## **2.2 Control and Instrument Systems**

The information in this section of the reference ABWR DCD, including all subsections, tables, and figures, is incorporated by reference with the following departures.

**Figure 2.2.1 Rod Control and Information System Control Interface Diagram**

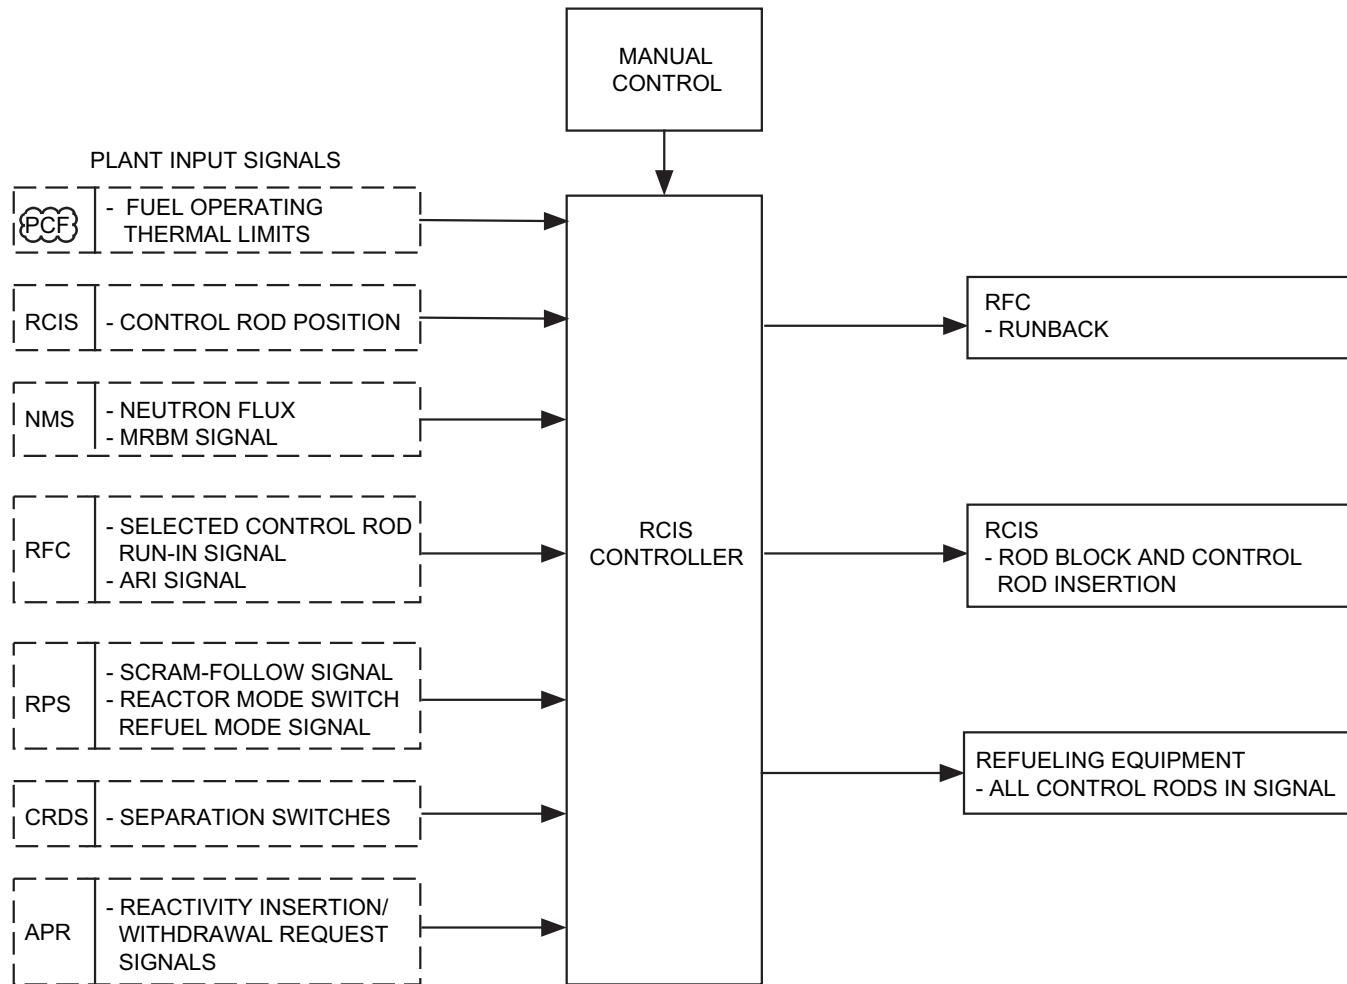
STD DEP T1 3.4-1 (Figure 2.2.1)

**Figure 2.2.5 Neutron Monitoring System**

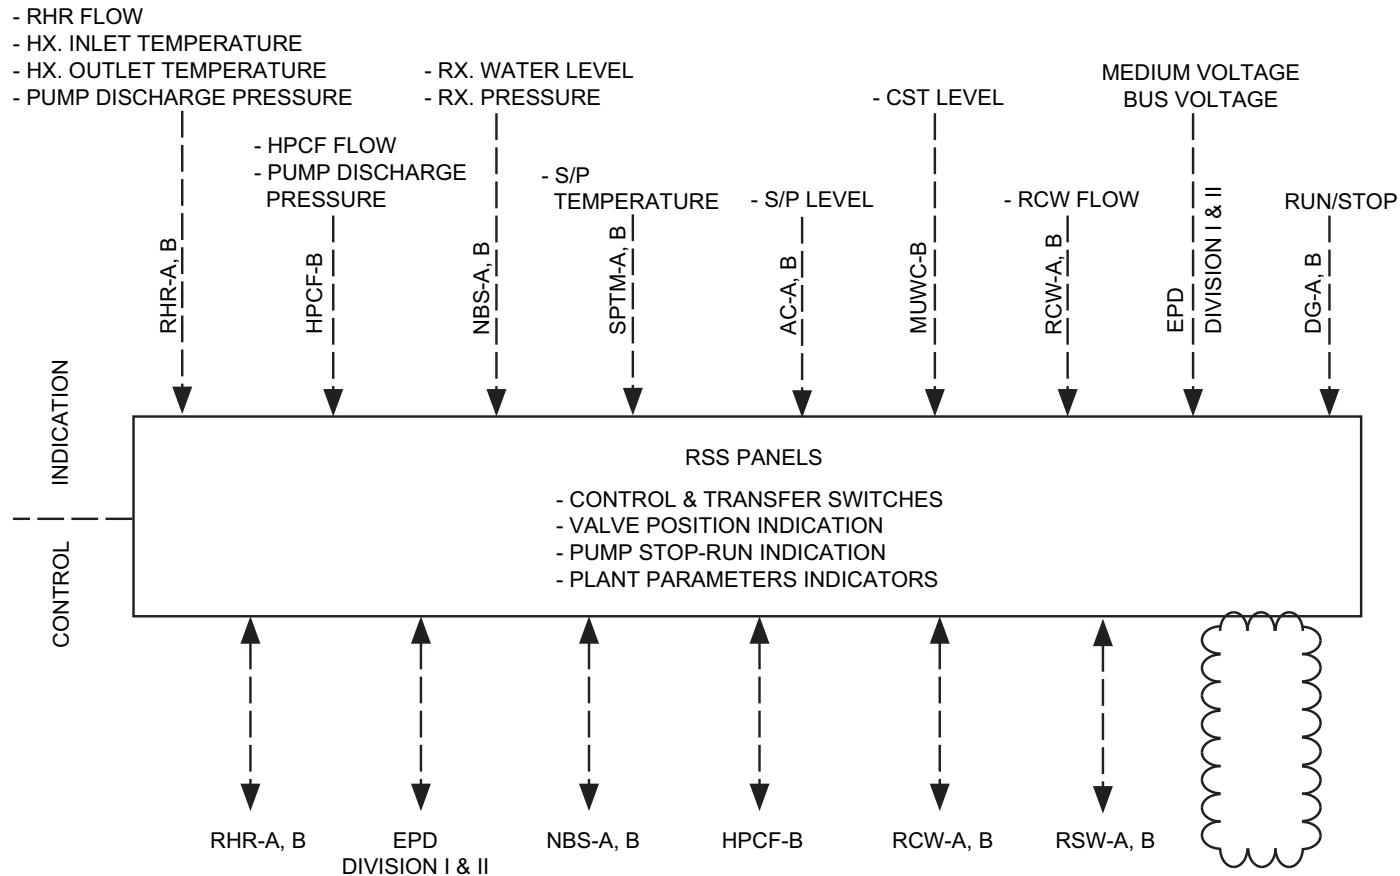
STD DEP T1 3.4-1 (Figure 2.2.5)

*The automated in-core instrument calibration system provides local power information at various core locations that correspond to LPRM locations. The automated in-core instrument calibration system uses its own set of in-core detectors for local power measurement and provides local power information for three-dimension core power determination and for the calibration of the LPRMs. The measured data are sent to the ~~Process Computer System~~ Plant Computer Functions for such calculation and LPRM calibration.*

**Figure 2.2.7b Reactor Protection System**

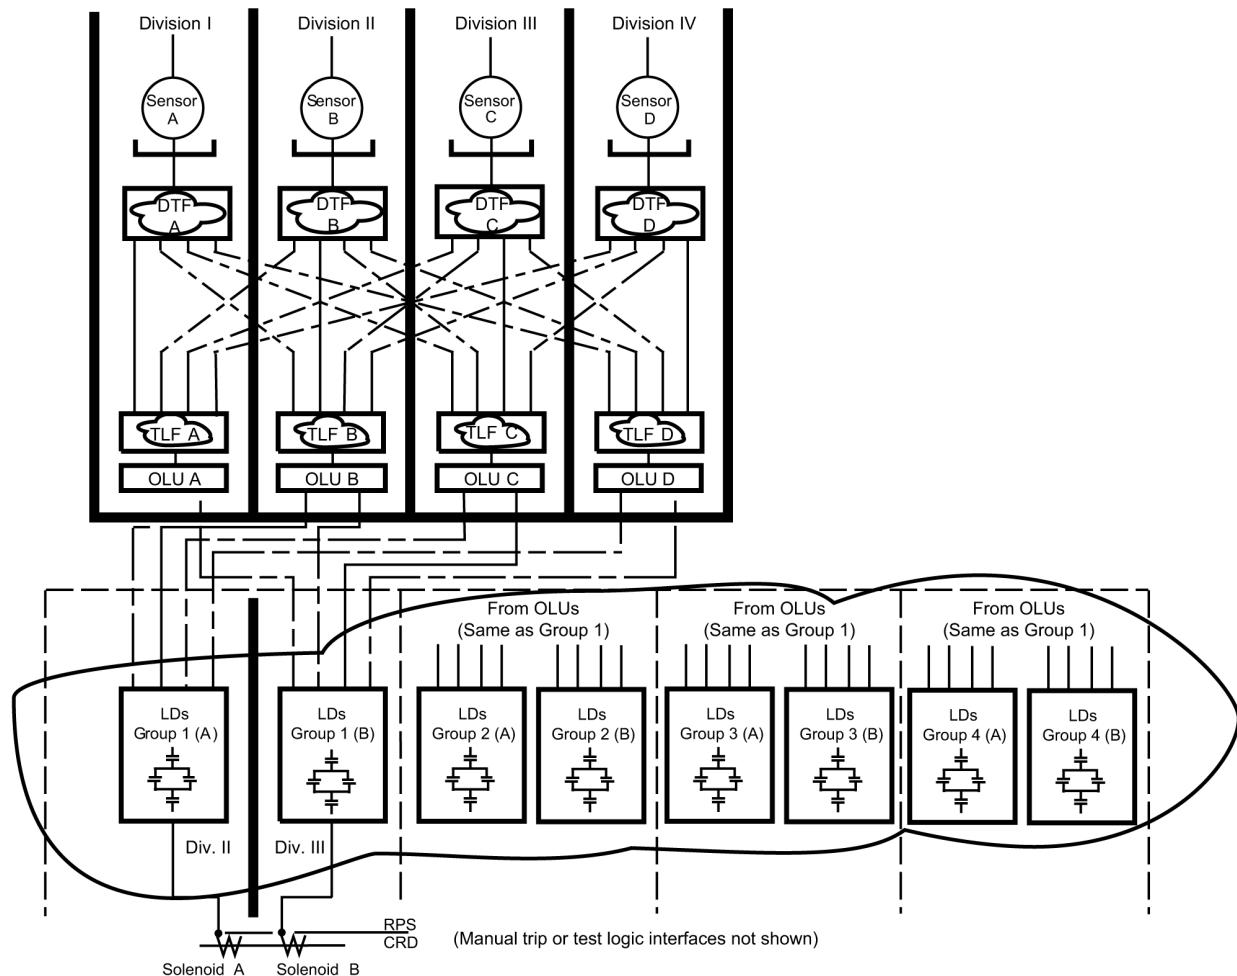
STD DEP T1 3.4-1 (Figure 2.2.7b)

The RPS has four divisions. Figure 2.2.6a 2.2.7b shows the RPS divisional aspects and the signal flow paths from sensors to scram pilot valve solenoids. Functions Equipment within an RPS division consists of include sensors (transducers or switches), I/O, multiplexers, data communication, digital trip modules functions (DTM DTF), trip logic unit function (TLU TLF), output logic unit (OLU), and load drivers (LD). The LDs are only in Divisions II and III. The (DTF) and (TLF) are performed in digital configurable logic devices. The data communication functions are described in Section 2.7.5.
